Access Compliance Report Public Rights-of-Way (Curb Ramps)

Main Street: BOLSA_AVE Cross Street: BEACH_BLV Location: SE

ADA ID: RPRK220202155504 Ramp Type: Type 4 - Parallel Initial Pass/Fail: Pass Overall Compliance: No Severity Score: 5

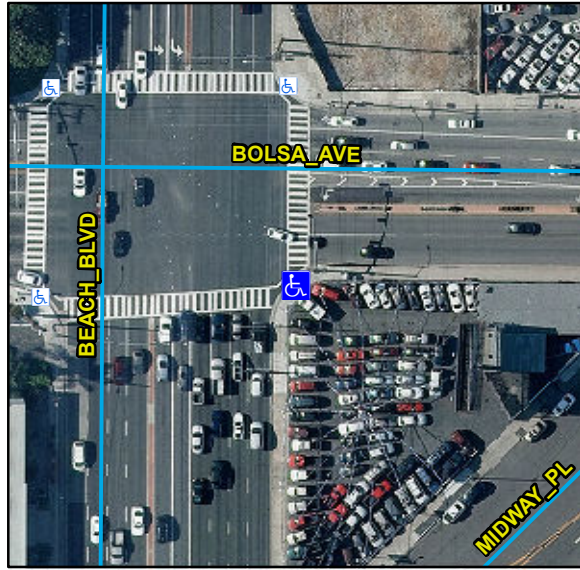
Surveyor Notes:

N/A

Possible Solutions:

Remove & Replace Detectable Warning System.

R305.1.3, STD 1115
